RIVERSIDE PARK EARLY LEARNING CENTRE 2826 SPRINGLAND DRIVE, OTTAWA, ON SERVICING AND STORMWATER MANAGEMENT REPORT

MAY 10, 2019
REVISION 1 – JULY 31, 2019

**SERVICING AND STORMWATER
MANAGEMENT REPORT**

**Subject: Manager Approval, Public Consultation, Site Plan Control Application
2826 Springland Drive**

Figure 3-11: Off-Road Multi-Use Pathway

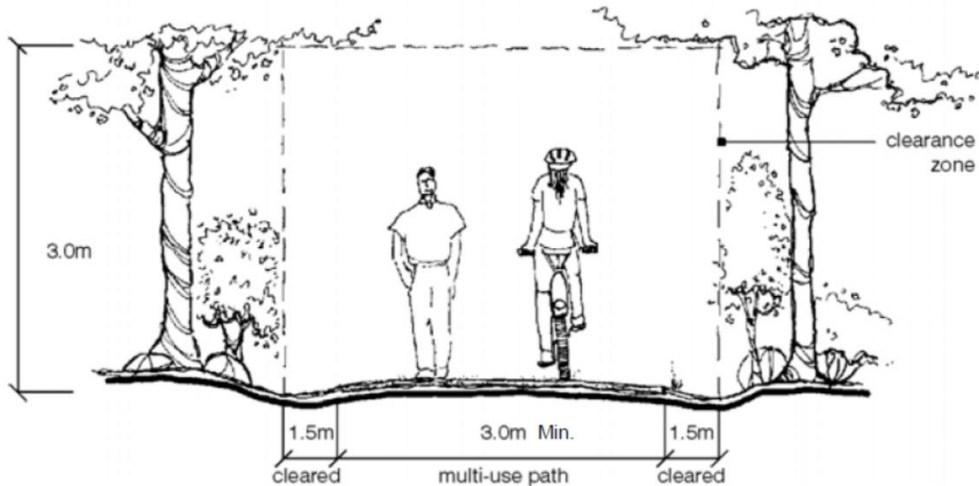
- 38.** Maintain a clearance space between the edge of the multi-use pathway and any plantings within the childrens' garden area.
- 39.** Locate the fence between the park and the enclosed play area 0.15m on the private side of the lot line.

- 40.** Please specify the fence type along the south side of the pathway corridor as a two-rail wood post and rail fence, and use the City of Ottawa's standard detail drawing No. F8 as a detail on the landscape plan. This will continue the same fence type that is proposed to the west between the park and church properties.

1 GRADING PLAN
C1 SCALE= 1:200

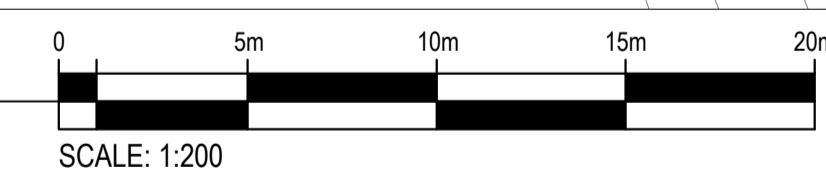
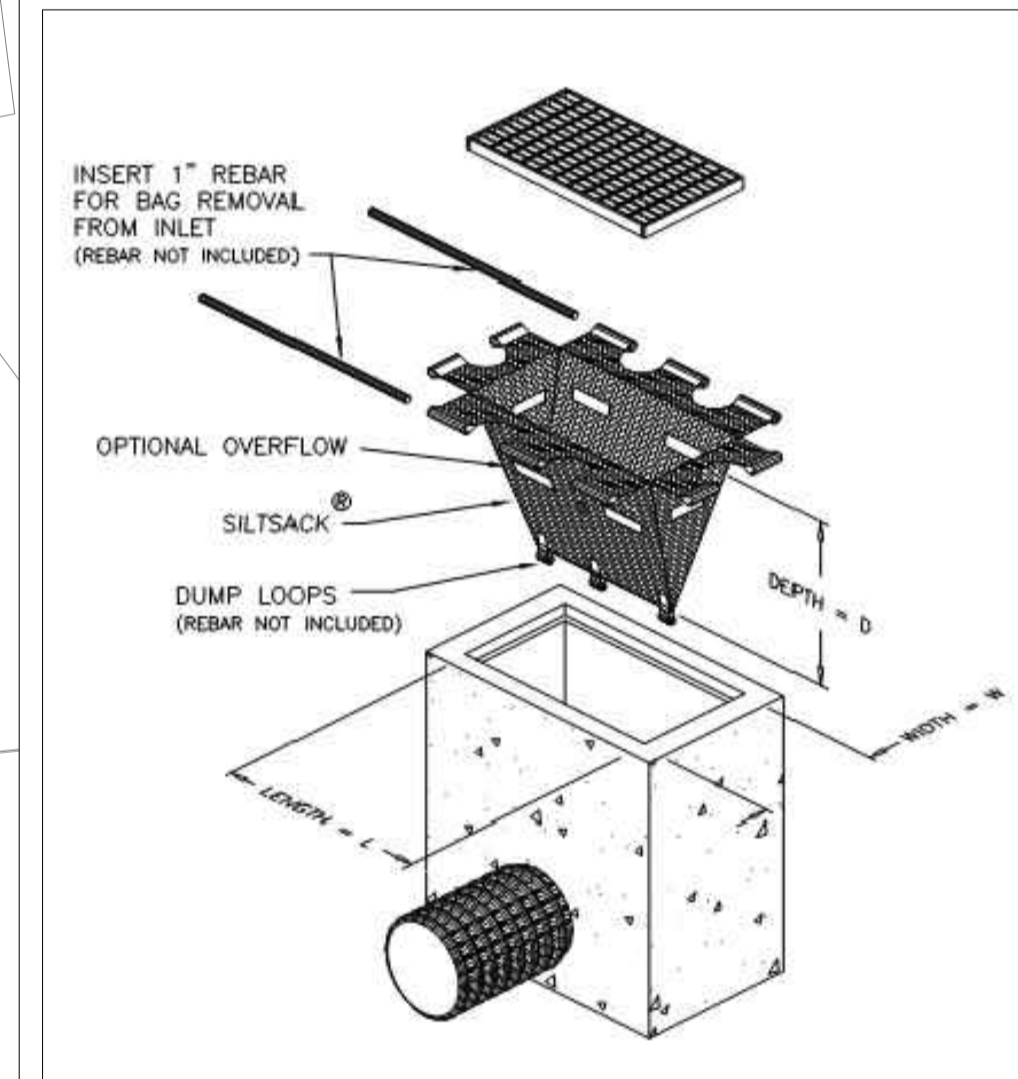
Grading Plan – Sediment and Erosion Control, C1, prepared by WSP, 191-03236-00, dated 2019-03-22, revision 1, dated 2019-05-10.

16. Identify or reference survey monument location.
17. Identify the emergency overland flow route.
18. Show surface ponding outline and elevations for 5-year and 100-year events.
19. Show the outline of the retaining wall that is identified by proposed grades on the north side of the property.
